U. S. NUCLEAR REGULATORY COMMISSION
REGION I

Report No. 50-219/93-18
Docket No. 50-219
License No. DPR-16
Licensee: GPU Nuclear Corporation
1 Upper Pond Road
Parsippany, New Jersey 07054
Facility Name: Oyster Creek Nuclear Generating Station (OCNGS)
Inspection Period: August 23-26, 1993 and October 18-20, 1993

ATTACHMENT 1

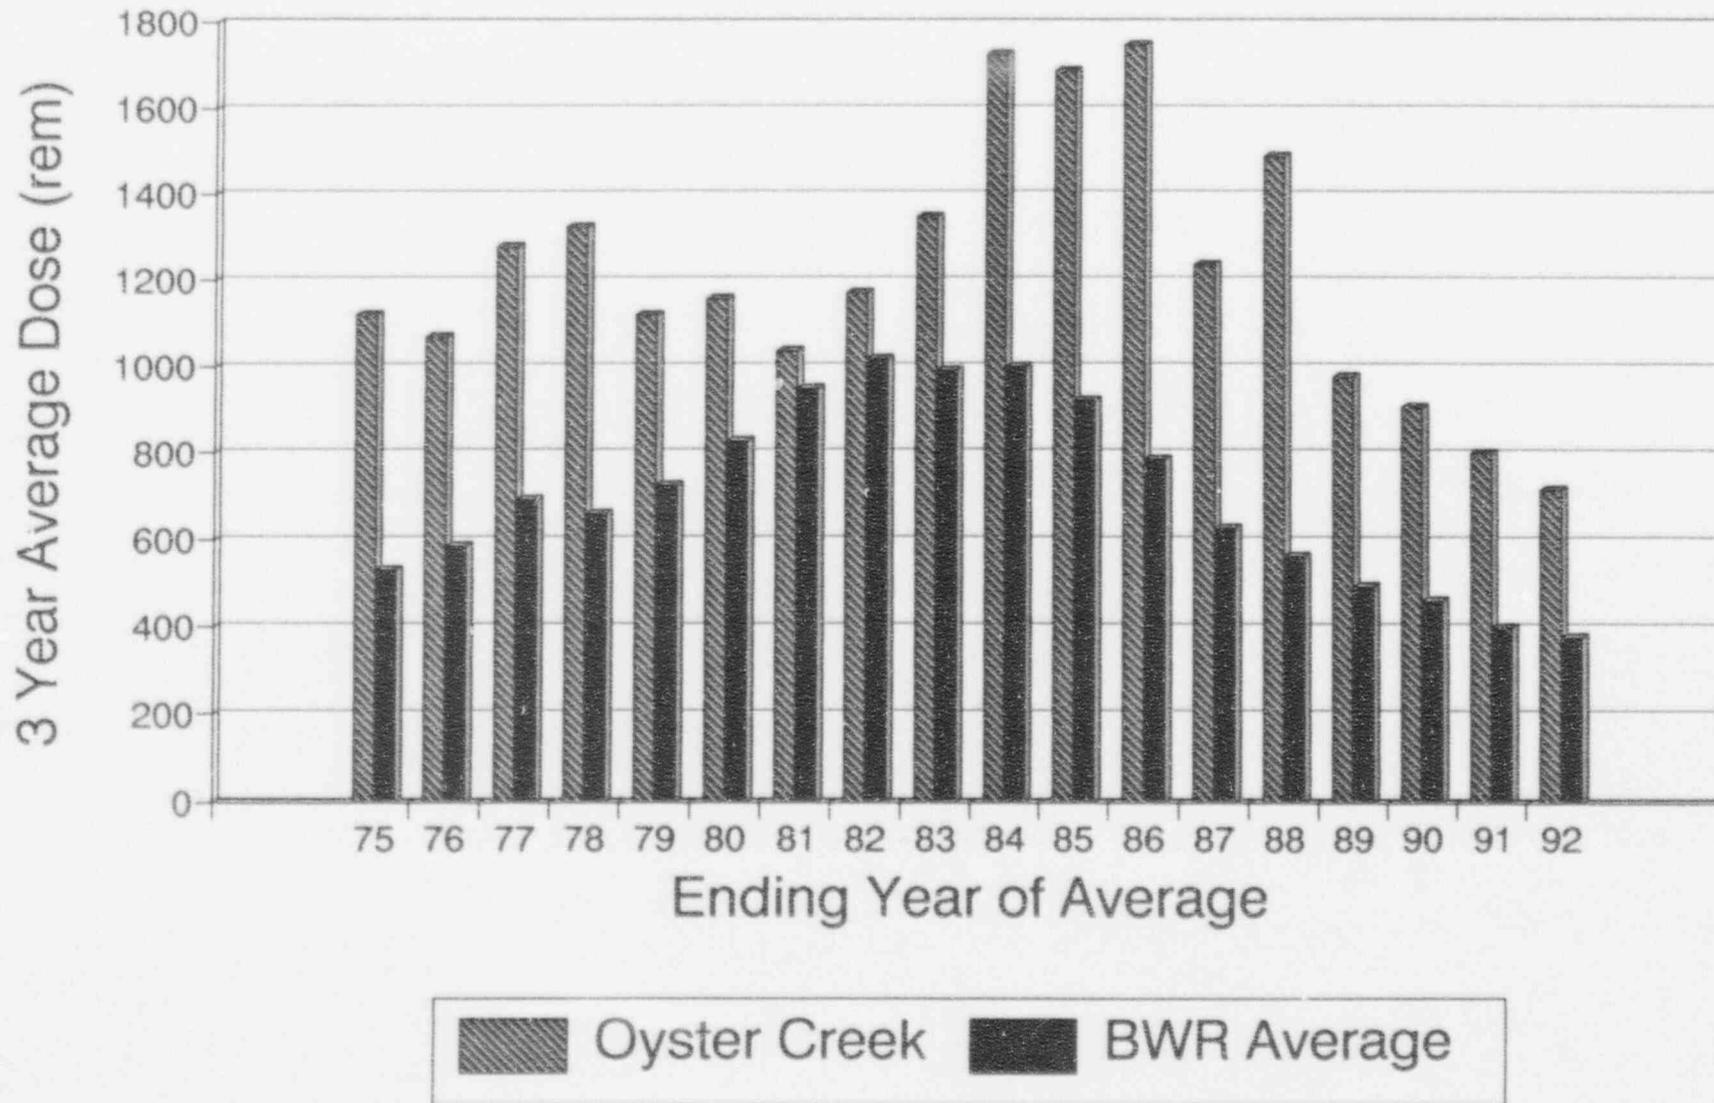
Licensee progress in this area is given in Section 2.6 of this report. See Attachment 1 for a graphical representation of the licensee's three-year rolling average cumulative exposure. While the graph shows OCNGS as being a high exposure BWR, it also shows that source reduction efforts have achieved significant results (the slope of the OCNGS curve is greater than that of the BWR average curve).
